July 12, 2024

NWB File: 2AM-WTP1830

Re: Response to Comments on the Whale Tail 2024 Modification under Water Licence 2AM-WTP1830

Figure 2-1: Predicted phosphorous (P) and nitrate (N-NO₃) concentrations in the IVR Attenuation Pond during Operations in the Whale Tail ELOM model as submitted (orange line), and with the updated nitrate and phosphorus sewage treatment plant source terms (v2; red line).

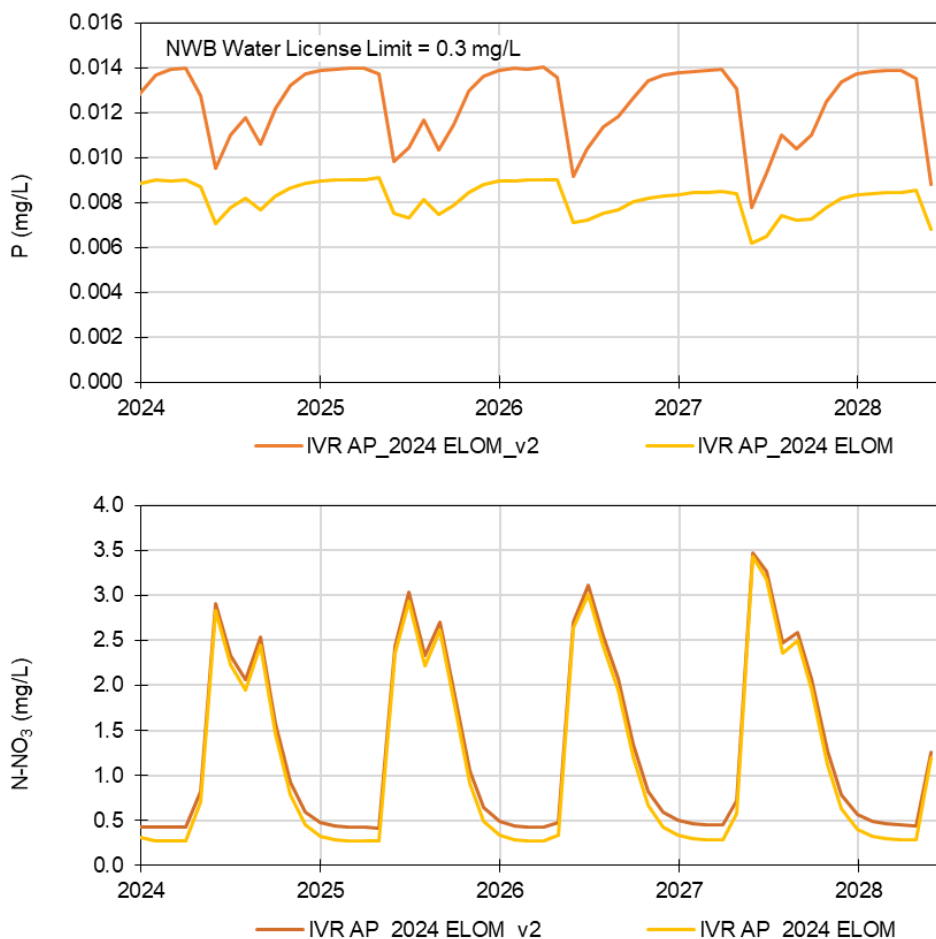
ECCC provides the following recommendations regarding the water quality model:

- *Ongoing sewage treatment plant challenges in meeting treatment targets for nitrate and phosphorus should be reflected in the source term development.*
- *Consider the potential for attenuation pond sediments to accumulate parameters and release these parameters into the receiving environment following reconnection to surface waters. Parameters should include, but not be limited to, phosphorus and arsenic.*
- *Consider how removal of attenuation pond sediments would affect the water quality predictions during operations, closure and post-closure.*
- *Review and update the model, as appropriate, to incorporate the above recommendations.*

To address the recommendation that challenges in meeting sewage treatment targets for nitrate and phosphorus be reflected in the source terms, the measured average effluent concentrations of both parameters from 2020/2021 were used as inputs to the WBWQM (Table 2-1). This results in an 11% and 52% increase in predicted Operations average IVR Attenuation Pond (primary receiver of STP effluent) concentrations of nitrate and phosphorus, respectively (Table 2-2 and Figure 2-1), noting that predicted phosphorus concentrations remain well below the NWB Water Licence limit of 0.3 mg/L.

Attenuation pond sediments may accumulate parameters during operations that are then released into the receiving environment following reconnection to surface waters. To address this potential pathway for contaminant release, a diffusive flux model was completed for WT AP in closure (note that IVR AP is backfilled during active closure). The calculations used operations results shown in Figure 2-1, which assumed elevated WTP effluent concentrations throughout operations (Table 2-1).

Figure 2-2: Predicted phosphorous (P) and arsenic (As) concentrations for the Whale Tail Pit during Operations in the Whale Tail ELOM model, as compared to the 2018 FEIS model.

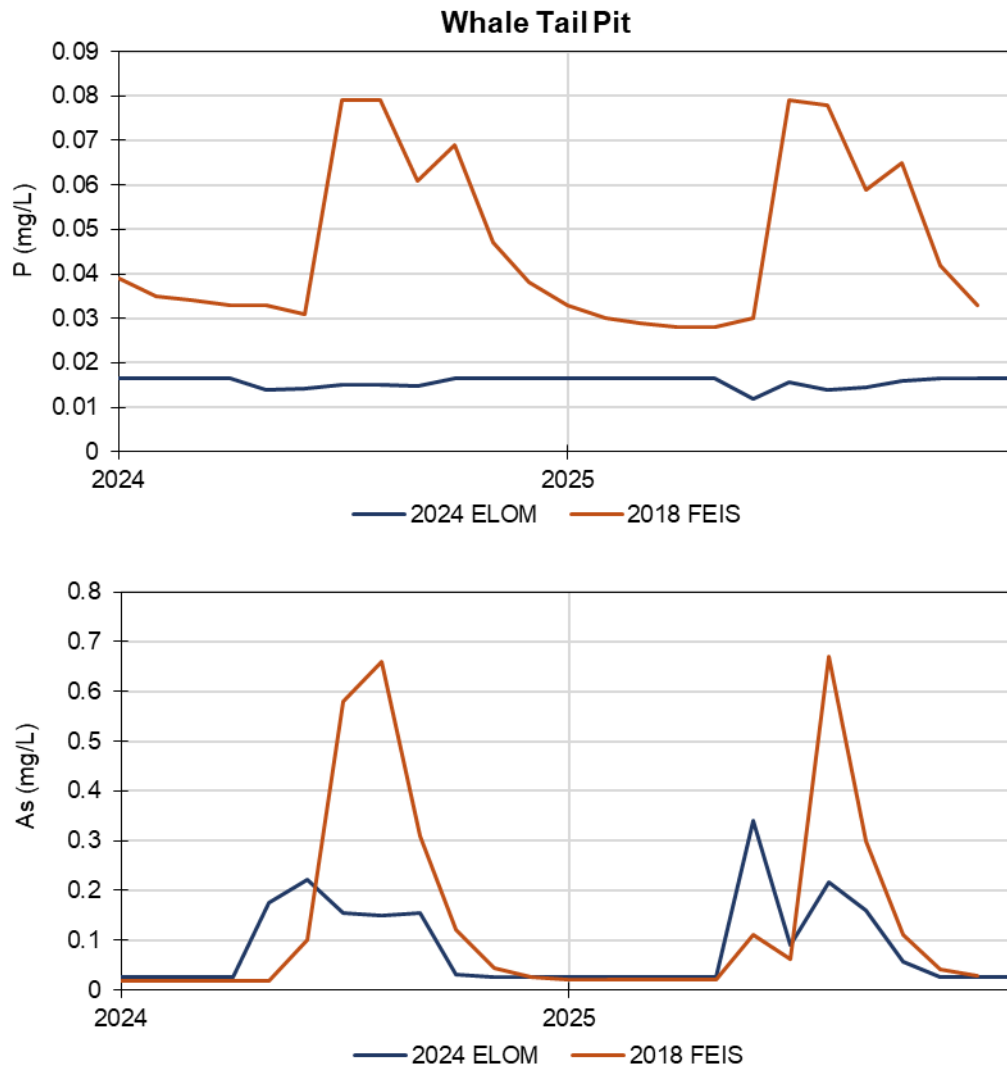
ECCC recommends that Appendix C (Whale Tail Water Balance and Water Quality Report), Section 6 (Water Quality Model Results) provide comparison figures depicting concentrations in pit lakes, attenuation ponds and treated effluent for the ELOM model as compared to the 2018 FEIS model.

The requested comparisons between the ELOM model predictions presented in Appendix C and 2018 FEIS model predictions are provided in Figure 2-2 through Figure 2-4. These comparisons are provided for 2024-2025, which defines the overlapping period with the 2018 FEIS mine plan, for arsenic and phosphorus.

In the Whale Tail Pit, predicted phosphorus concentrations are substantially higher in all seasons in the 2018 FEIS model predictions, relative to the 2024 ELOM model (Figure 2-2). Winter arsenic concentrations are generally comparable between the two models; however, the predicted arsenic concentrations are elevated in the open water season in the 2018 FEIS model relative to the 2024 ELOM model, with the exception of May and June.

Figure 6-7: Predicted phosphorous (P) and arsenic (As) concentrations for the IVR Pit during Operations in the Whale Tail ELOM model.

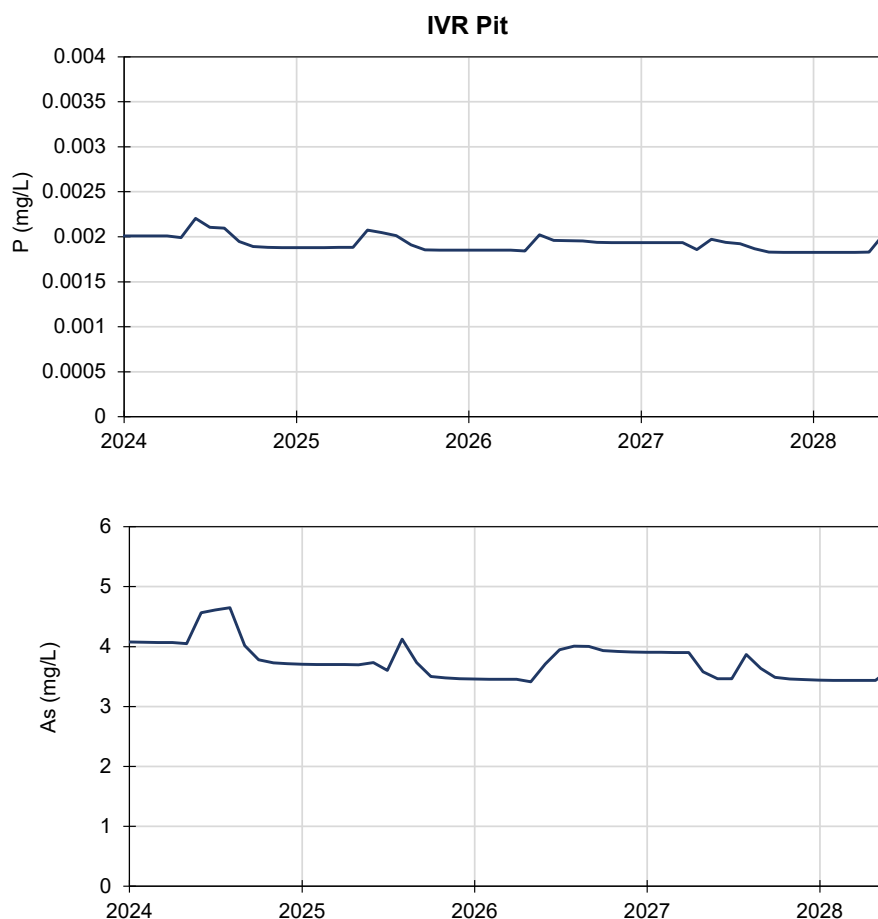
ECCC recommends that the Proponent review the title of Figure 6-2 in Appendix C (Whale Tail Water Balance and Water Quality Report) and correct as needed.

ECCC is correct, Figure 6-2 was mislabelled in Appendix C. Figure 6-2 is replicated below with the correct label.
